Municipal Standards

Review Notes (2024-2025)

EAST HANTS

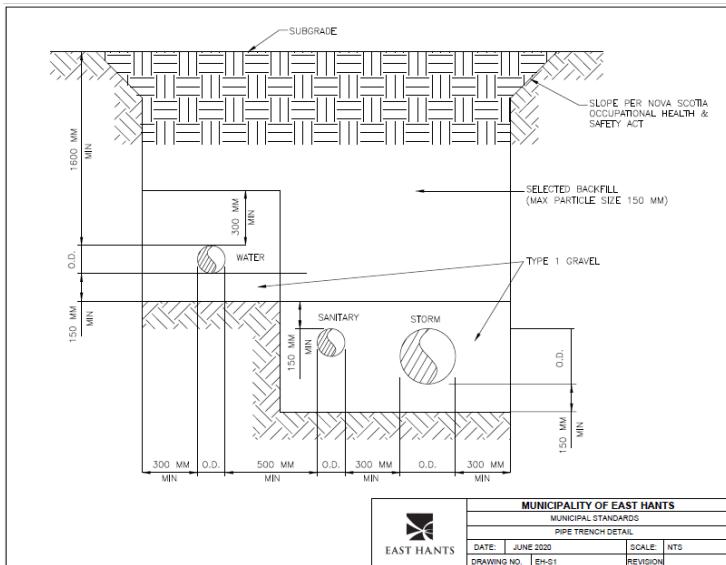
Delete Sub-sections 3.5.6 and replace with the following:

.6 Set manhole frame and cover to elevation and slope indicated. Centre frame over capping ring.

1. For 150 mm & 300 mm grade adjustments: Use precast grade rings, maximum of 2, minimum 150 mm thickness. Secure frame in place as per manufacturer's instructions.

2. For 75 mm to 150 mm grade adjustments: Use cast-in-place 35MPa concrete. Cast-in-place concrete shall not exceed the outside edge of the capping ring. Formwork, grade stakes, shall not be permitted within the adjustment concrete or in the concrete between the frame and the capping ring. Frames shall be supported by all sides of the cast-in-place grade adjustment.

3. For 25 mm to 75 mm grade adjustments: Use epoxy mortar. Epoxy mortar shall not exceed the outside edge of the capping ring. Formwork, grade stakes, shall not be permitted within the adjustment concrete or in the epoxy mortar between the frame and the capping ring. Frames shall be supported by all sides of the epoxy mortar grade adjustment.

PIPE TRENCH DETAIL EH-S1

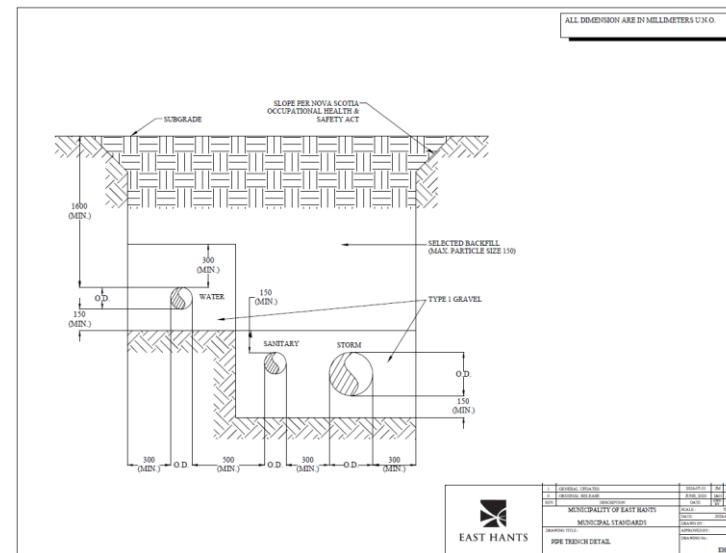
ORIGINAL

RECOMMENDED REVISION

SEMI-DETACHED SERVICE CONNECTIONS EH-S2

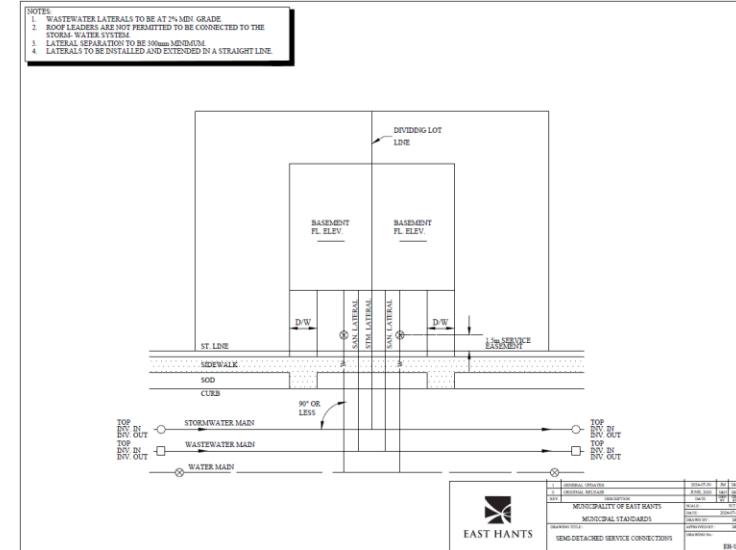
ORIGINAL

RECOMMENDED REVISION

AIR RELEASE/AIR VACUUM VALVE CHAMBER EH-S4

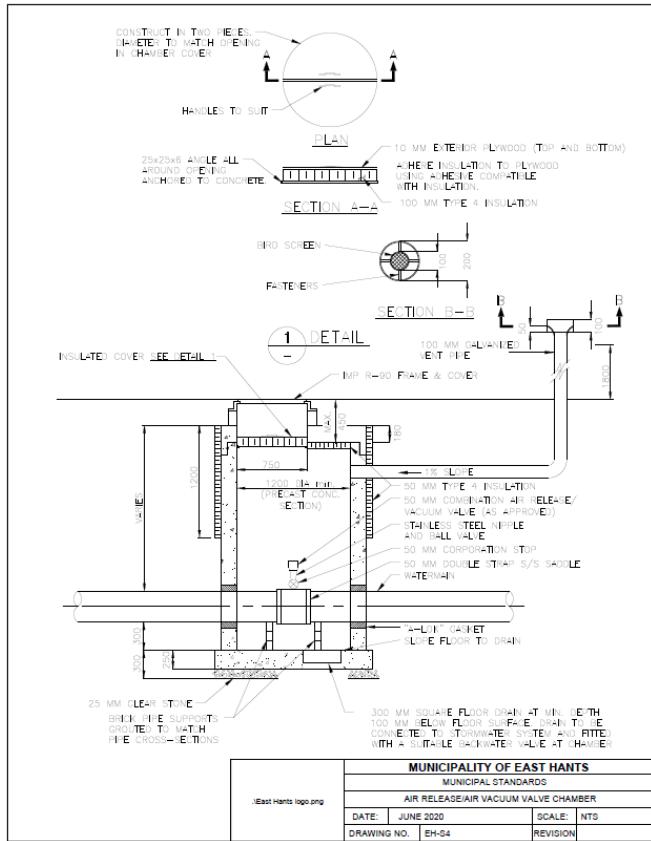
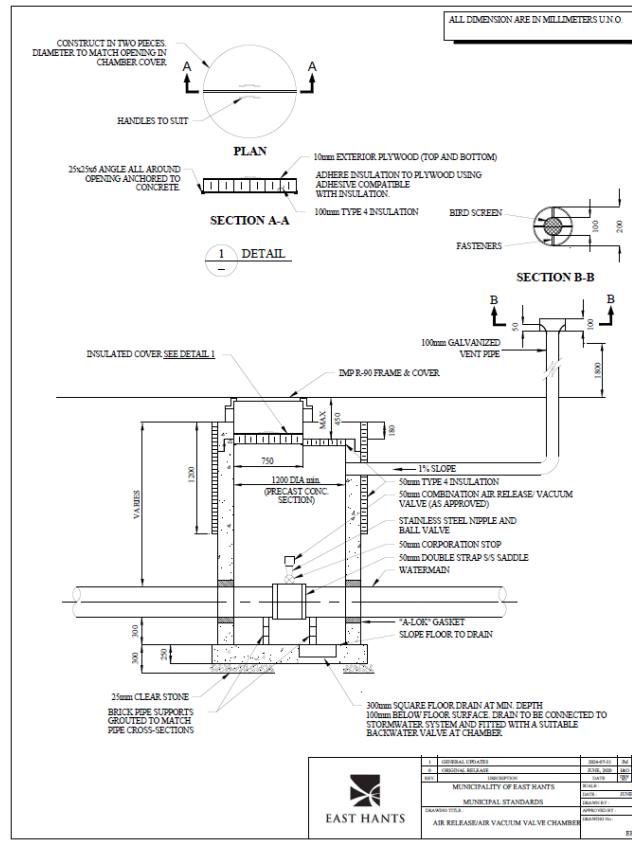
ORIGINAL

RECOMMENDED REVISION

TYPICAL ROAD CROSS SECTION EH-T1

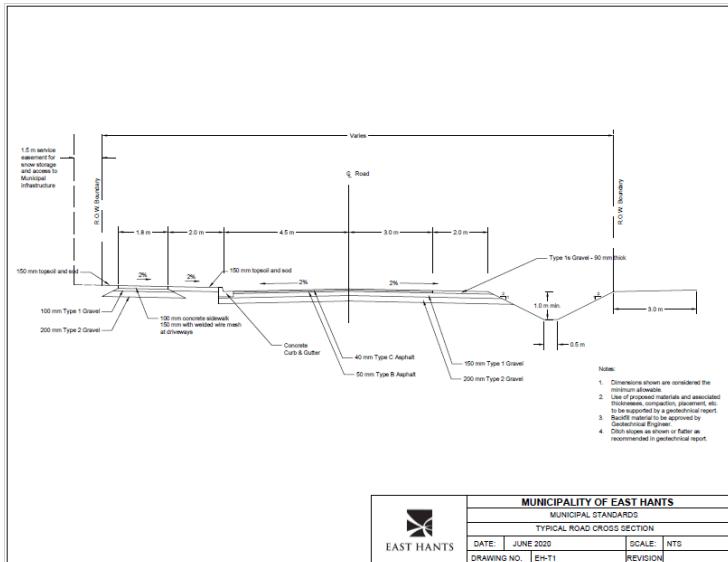
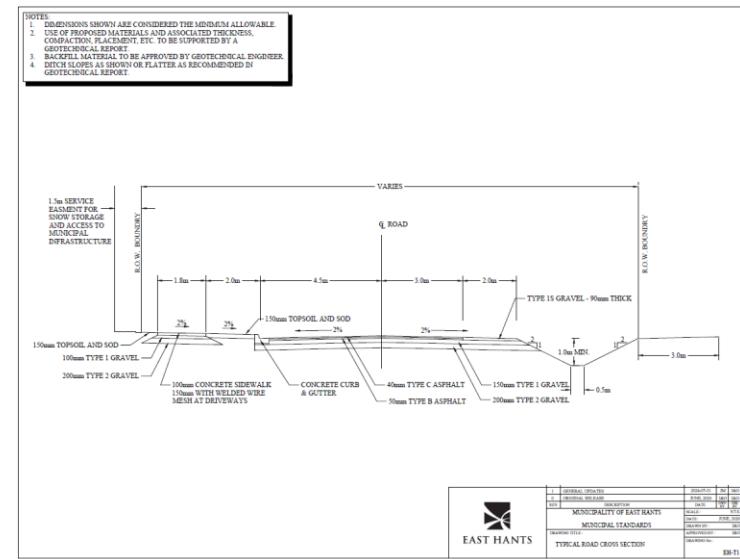
ORIGINAL

RECOMMENDED REVISION

RURAL CUL-DE SAC EH-T2

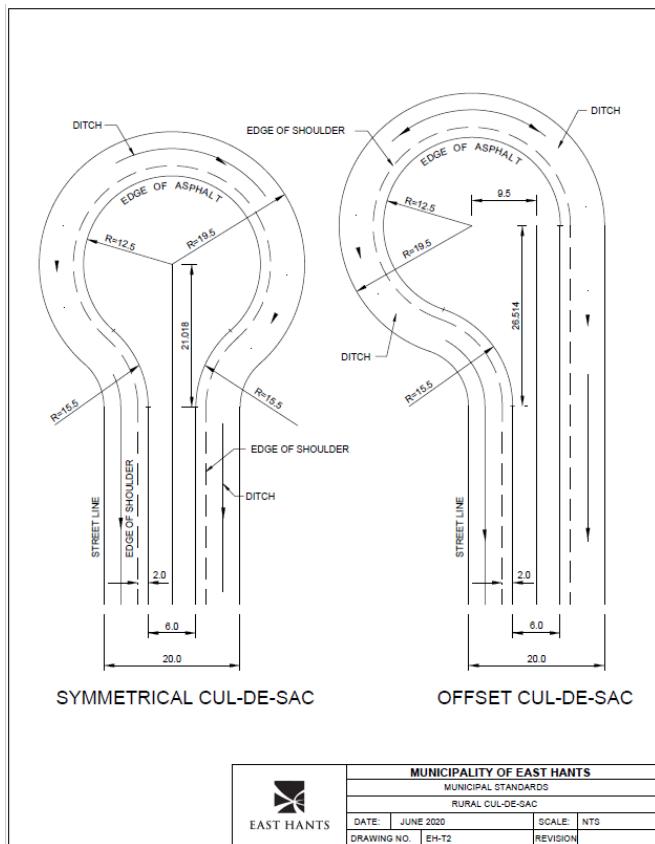
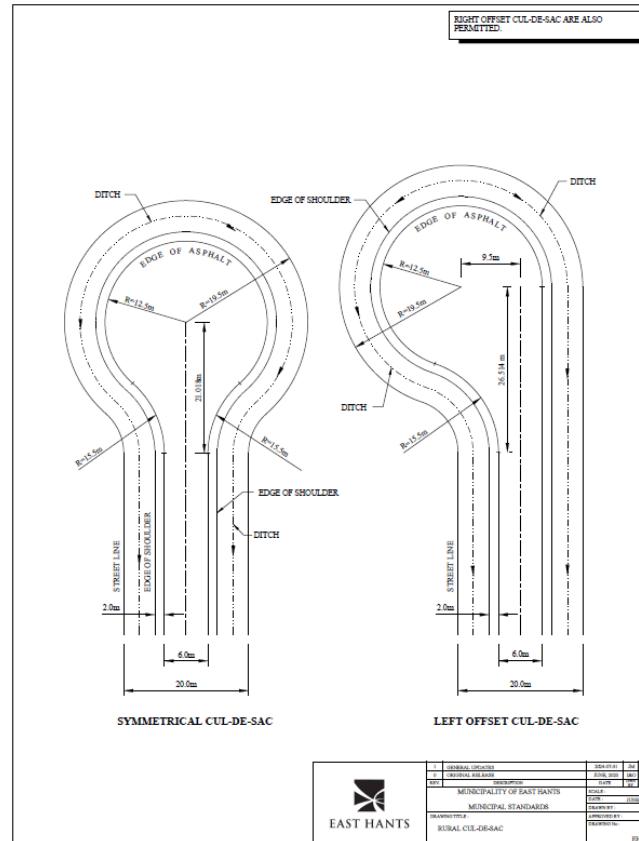
ORIGINAL

RECOMMENDED REVISION

URBAN CUL-DE-SAC-T3

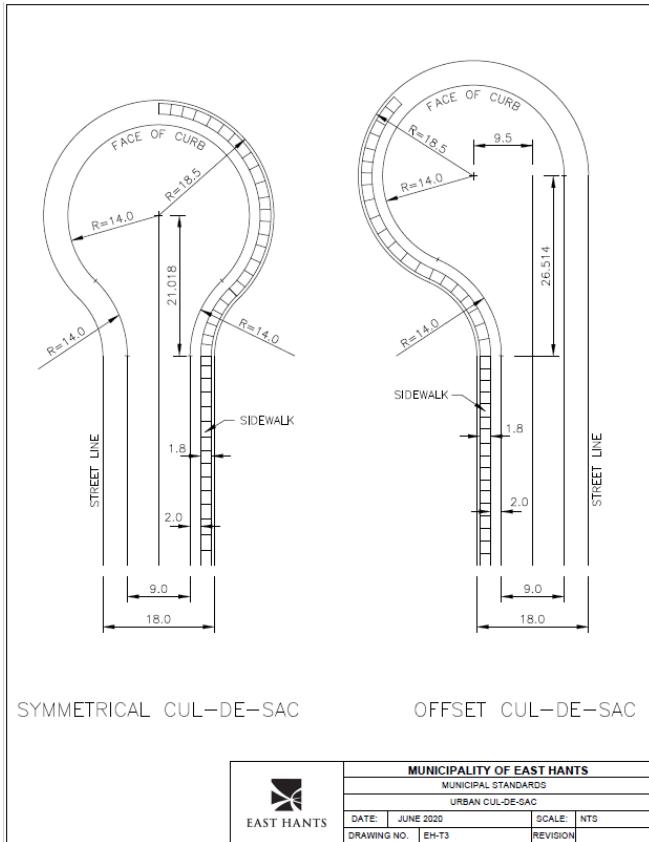
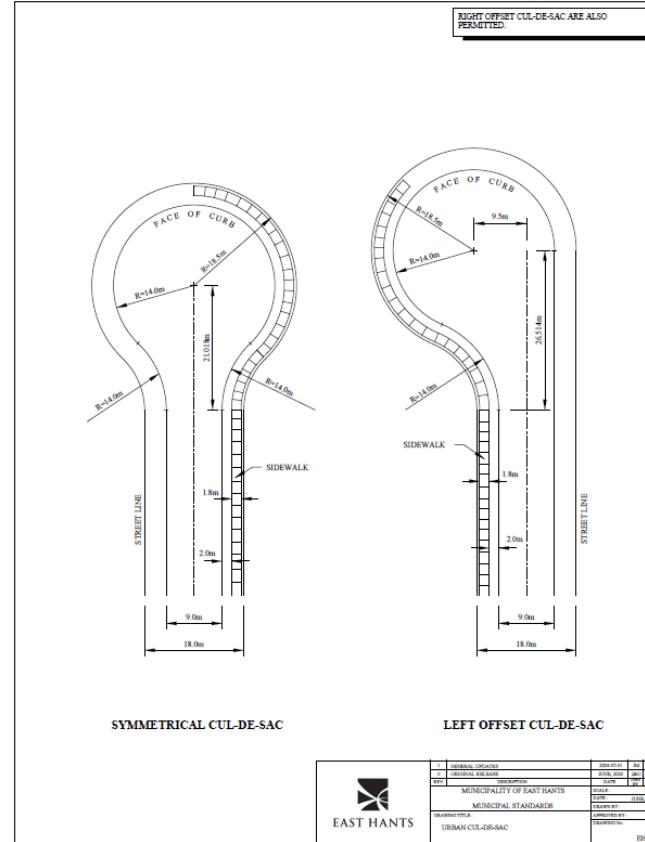
ORIGINAL

RECOMMENDED REVISION

INDUSTRIAL STREET ROAD CONSTRUCTION THICKNESS EH-T4

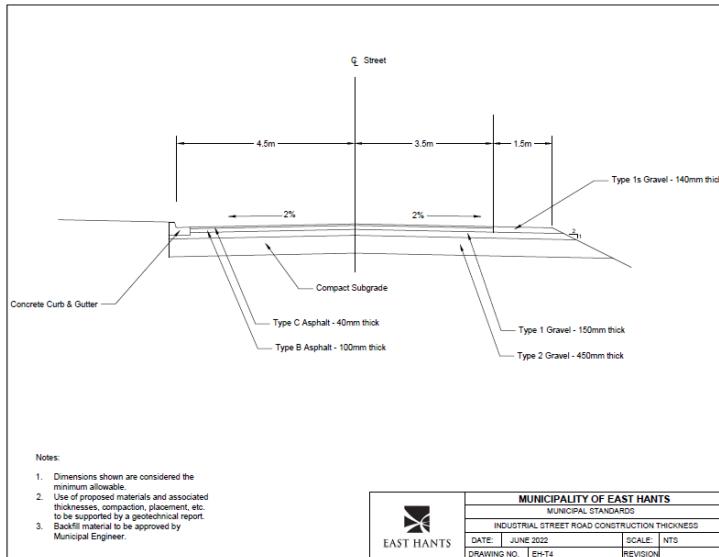
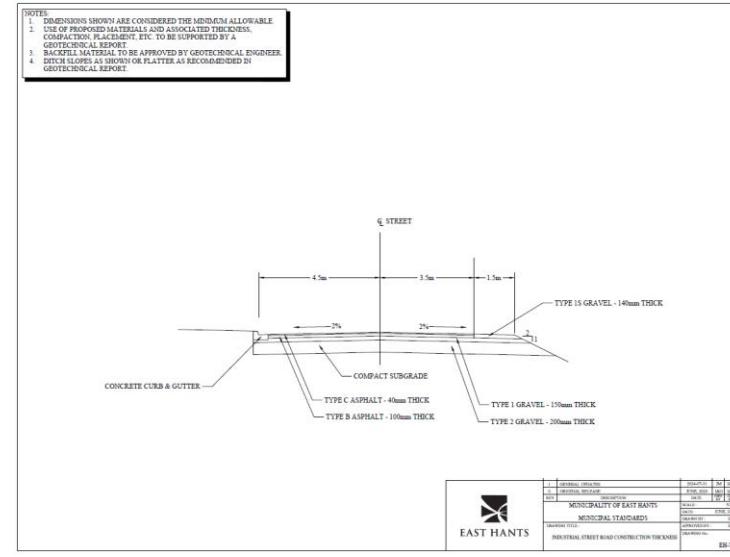
ORIGINAL

RECOMMENDED REVISION

TYPICAL SIDEWALK EH-T6

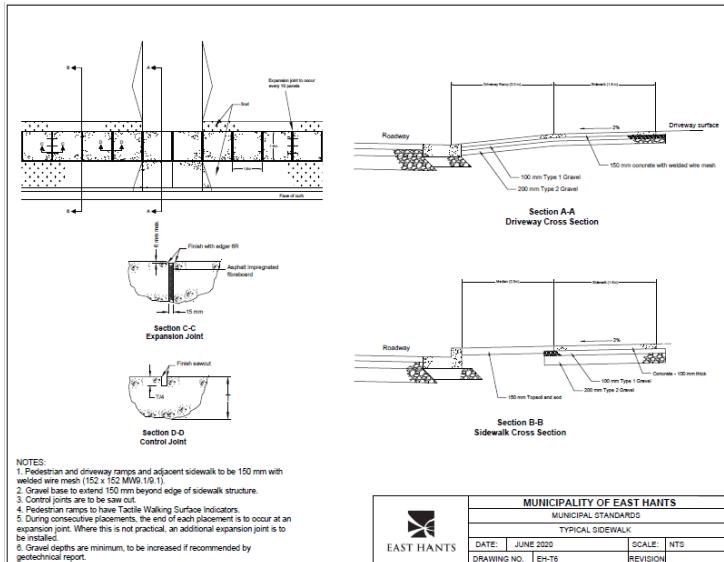
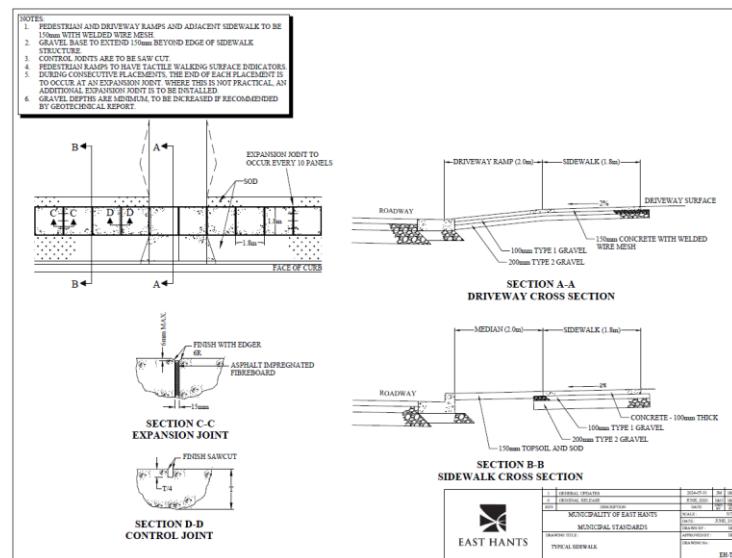
ORIGINAL

RECOMMENDED REVISION
